Geebee (Bangladesh) Ltd.

10th June 2014

Observations

Global stability

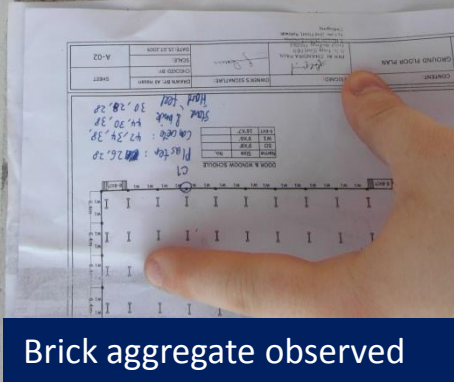
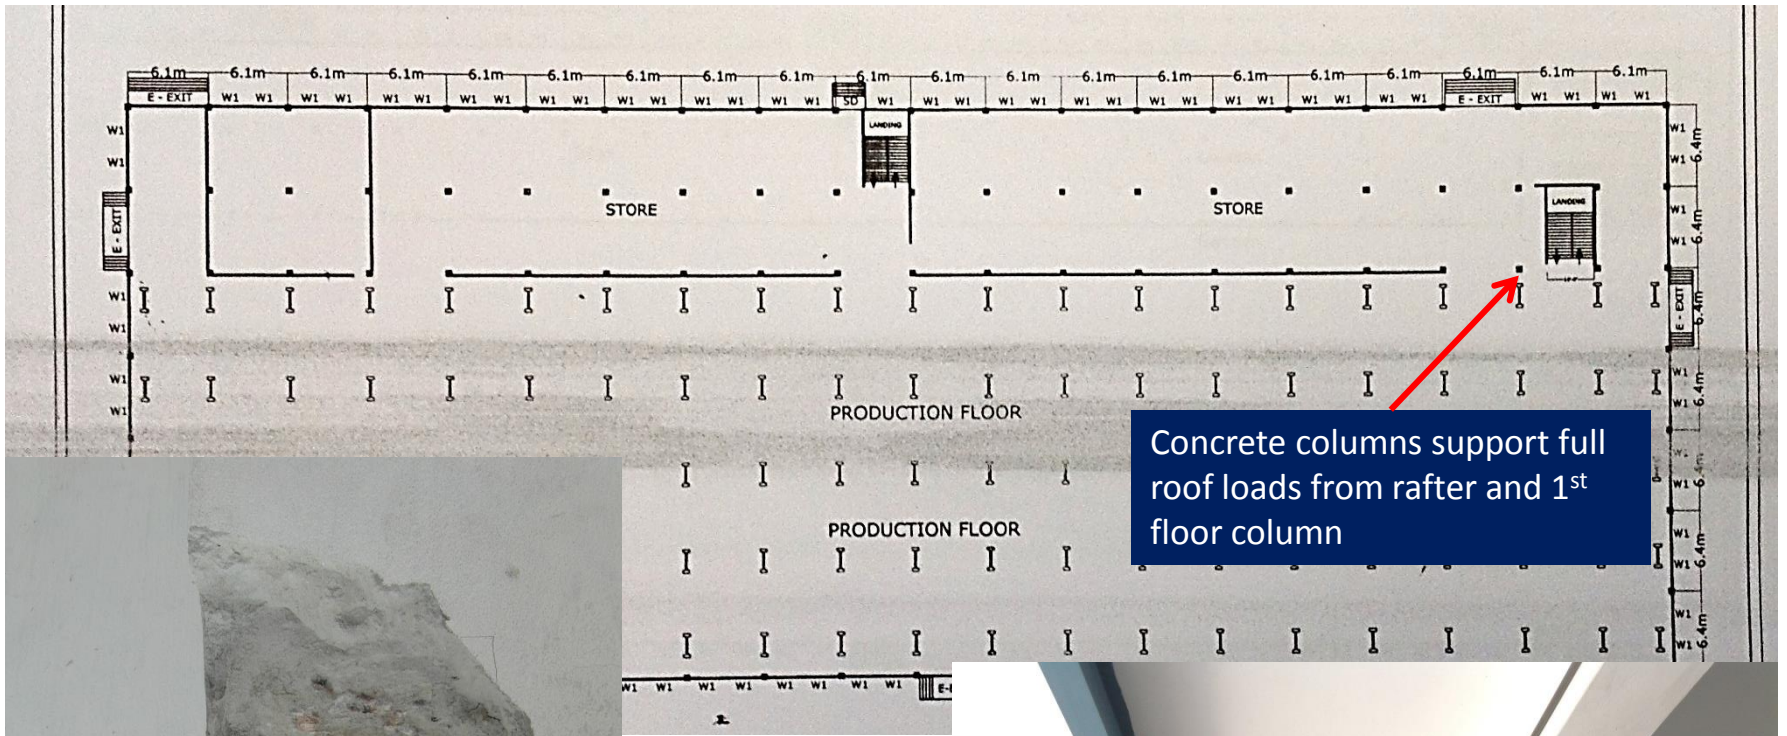
Packers placed under flange instead of under entire section – reduces moment capacity of joint

Few internal masonry walls at ground floor to act as shear walls – lateral stability of upper floors unclear

Top flange cut away and additional angle poorly welded with poor detailing – reduced flexural and shear capacity of beam

High column stresses

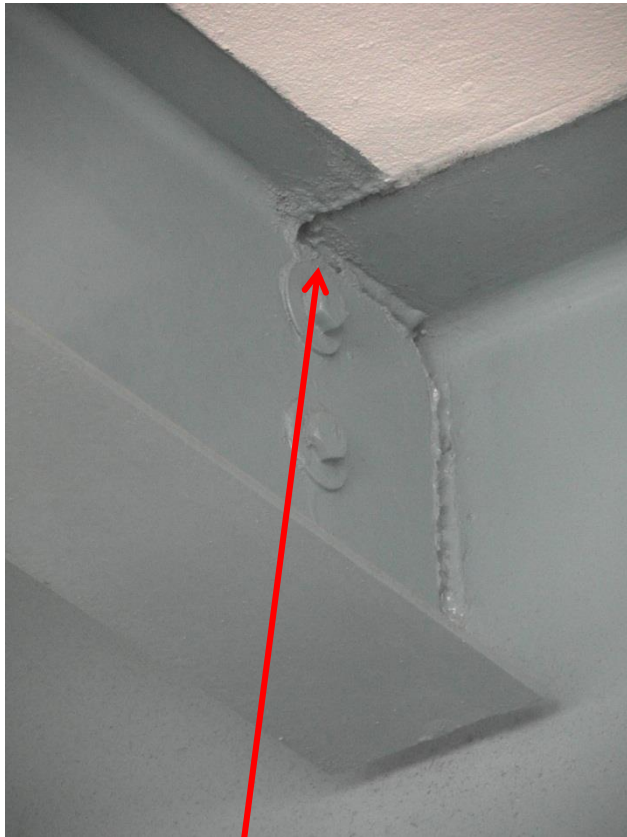
Brick aggregate observed

7	High stresses in ground floor RC columns	Continue to implement loading plan	6-months

Poor steel detailing

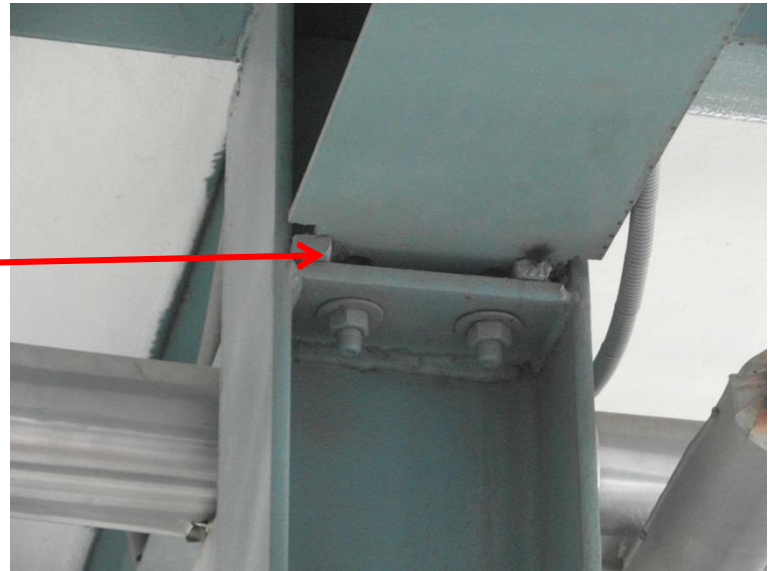
Edge distance to bolts appears too low

Packers placed under flange instead of under entire section – reduces vertical capacity of connection

Top flange cut away and additional angle poorly welded with poor detailing – reduced flexural and shear capacity of beam

Poor portal frame haunch detailing

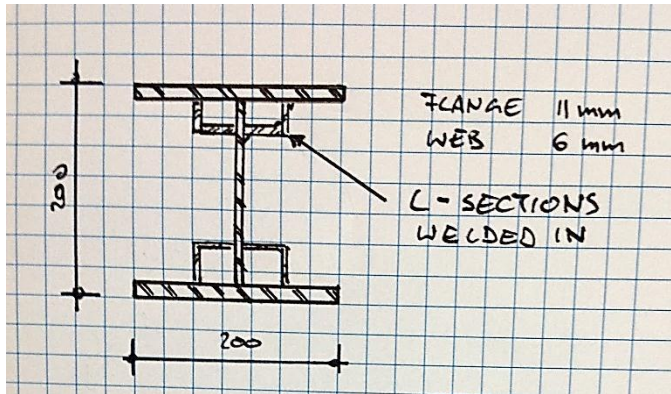
Column does not appear large enough to resist bending moments from haunch and rafter for vertical loads.

Poor haunch detailing (no stiffeners, no tension plate, welding very poor quality)

Item No.	Observation	Recommended Action Plan	Recommended Timeline
8	Poor portal frame haunch detailing	Building Engineer to review portal frame design as built, including haunches, column sizes and weld quality	6-weeks
9	Poor portal frame haunch detailing	Provide remedial details as appropriate	6-weeks
10	Poor portal frame haunch detailing	Carry out remedial work as required	6-months
11	Poor steel detailing	Building Engineer to review steel detailing and weld quality	6-weeks
12	Poor steel detailing	Provide remedial details as appropriate.	6-weeks
13	Poor steel detailing	Carry out remedial work as required	6-months
14	Apparently non-engineered external structures	Building Engineer to review design of ancillary steel structures with regard to their capacity to support code vertical and wind loads	6-months
15	Apparently non-engineered external structures	Carry out remedial works as necessary, or replace structures	6-months

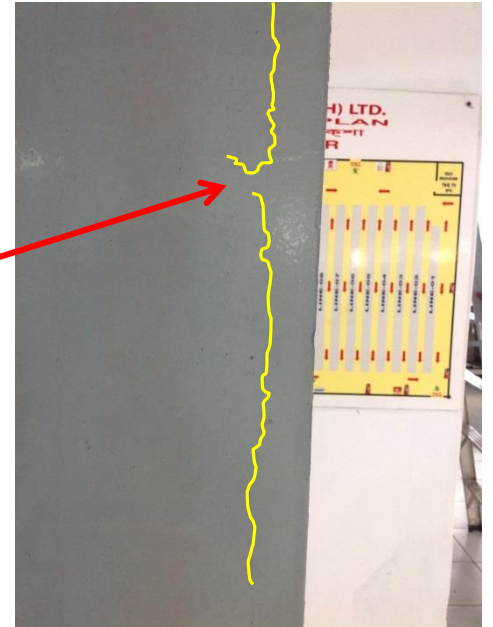
Cracks to paint and bowing of plates suggest flanges may have locally buckled slightly. L-sections were apparently welded on later to strengthen the column

Incorrect details on Permit drawings

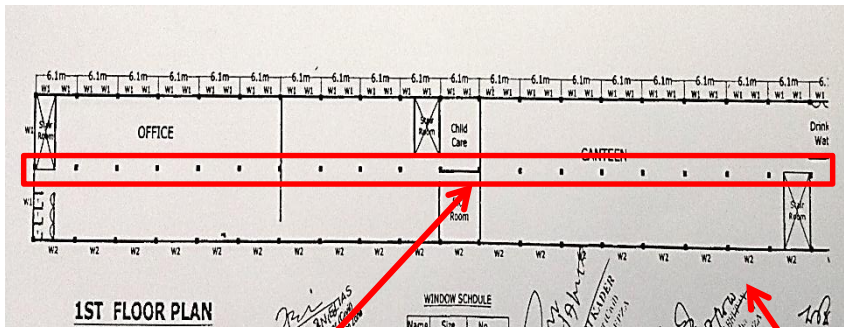
1st floor not shown

Incorrect dimension

Ground floor columns not shown

Columns on 1st floor not existent

16	Absence of structural information and inconsistencies between drawings and as-built construction	Building Engineer to carry out as-built survey of building and produce accurate and complete as-built drawings	6-months
17	Absence of structural information and inconsistencies between drawings and as-built construction	Building Engineer to provide structural documentation for external steel structures.	6-months

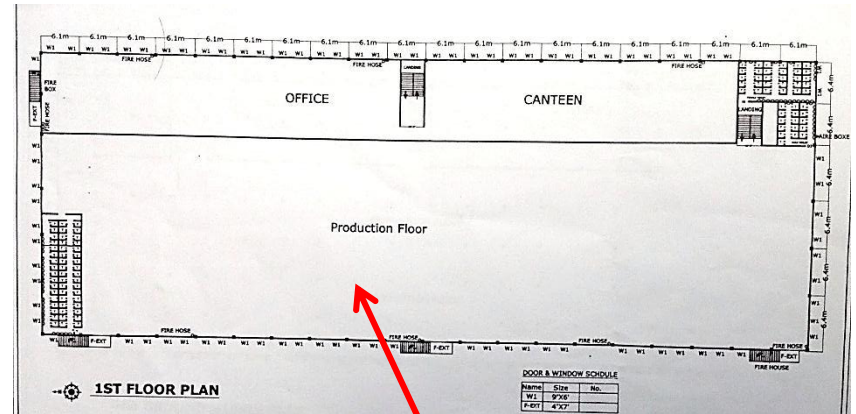
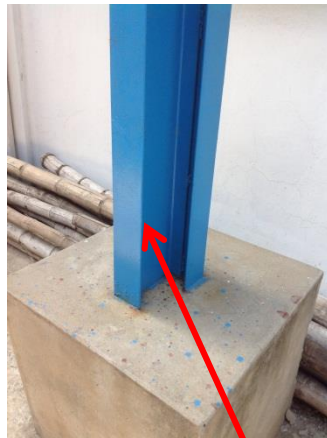
Two different floor plans provided. Some column sizes shown are different from as-built
